STAFF REPORT

CSP 2010-PR-014-02

PROPOSAL: Comprehensive Sign Plan associated with RZ/FDP 2010-PR-014D

Title of CSP: Adaire at Spring Hill Station, Land Bay – D2A, Comprehensive Sign Plan

ADAIRE AT SPRING HILL STATION
P-2 IDENTIFICATION - TOWER SIGN - SOUTH

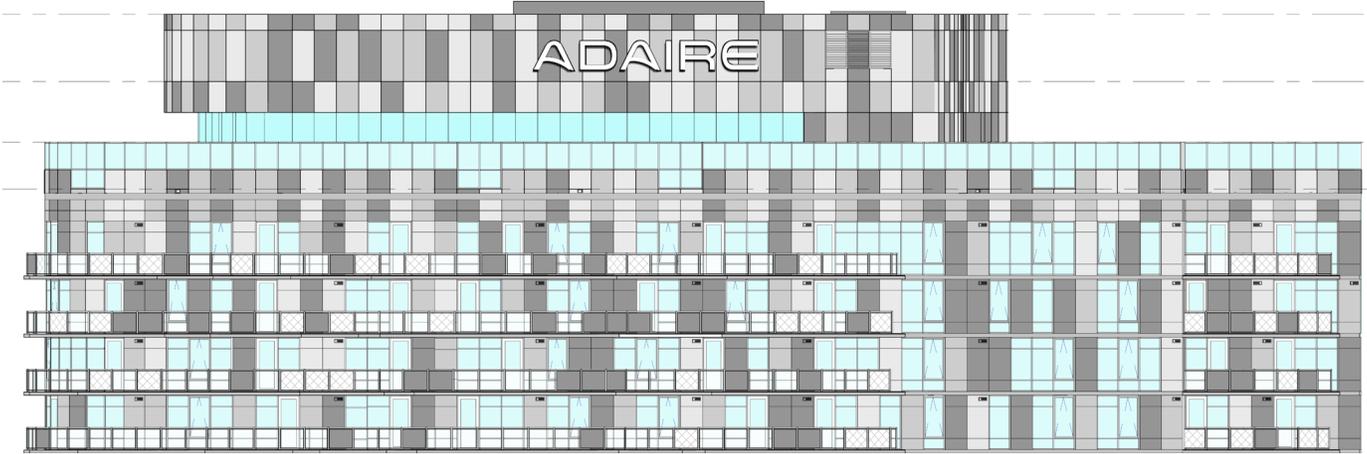
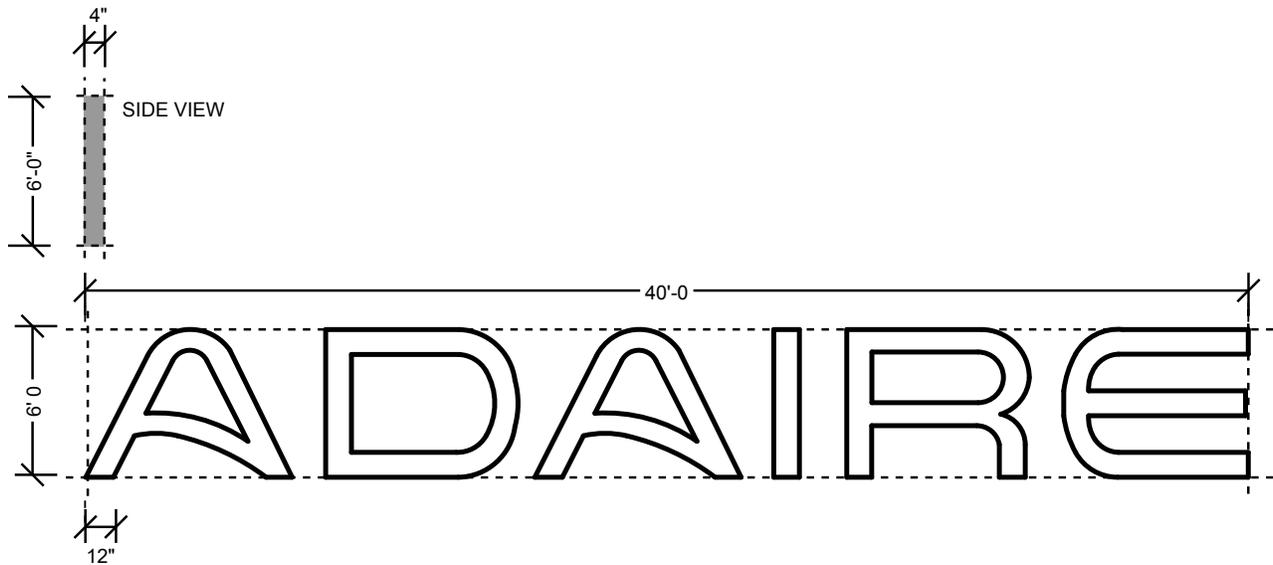
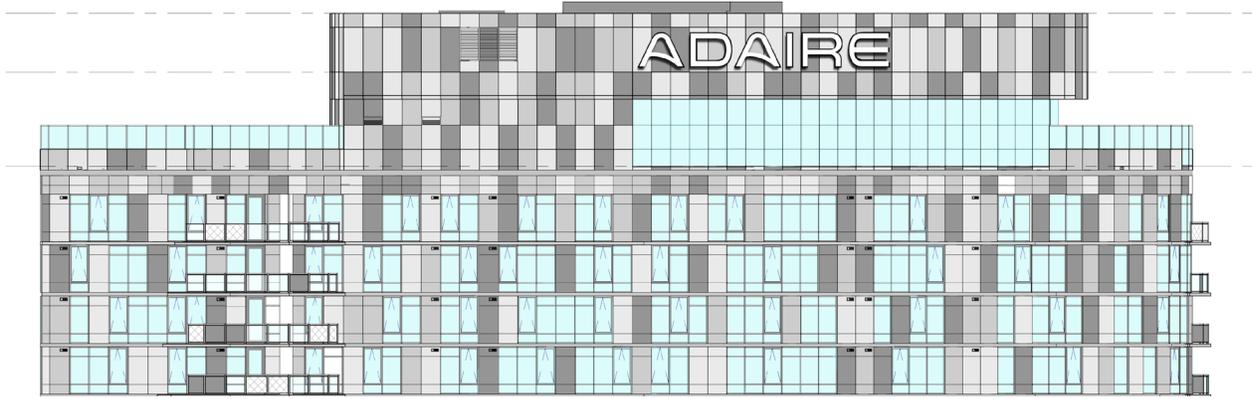
Overall, staff finds that the proposed signs are in scale with the size and location of the 35-story residential tower. However, the Office of Community Revitalization offered two recommendations. First, staff noted that the proposed building-mounted signage at the top of the building may not provide enough contrast with the building colors and Mondrian geometric finish which, in turn, could result in reduced visibility, especially during the daytime hours. To that end, staff recommends a development condition

which would allow the applicant to provide a thicker outline on the lettering of these signs if additional contrast for the sign is needed.

The applicant has proposed two building identification signs that will be mounted on the building tower. OCR has concerns that the signs, shown on pages 15-18, may not provide enough contrast with the building colors and may have reduced visibility, especially during the daytime hours. OCR suggests that the applicant be given flexibility to provide a thicker outline on the lettering, should additional contrast be desired in the future.

ADAIRE AT SPRING HILL STATION
T13 - TEMPORARY MARKETING BANNER

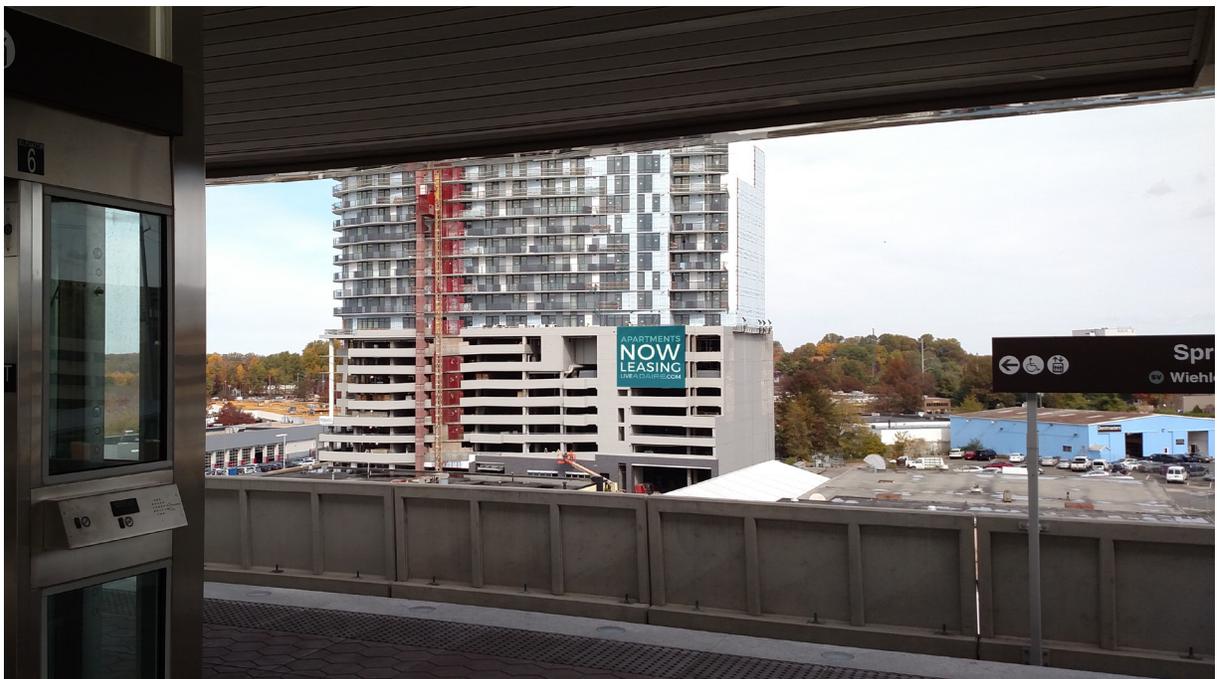
The temporary banner signs proposed for the building are in scale with the size and location of the building, and are well placed along the building façades. Signs T13 & 14 (Page 26) propose a blue background with blue text. OCR recommends that the CSP not limit the colors on the signs, so that, if desired, the applicant can modify the color to provide greater visibility.
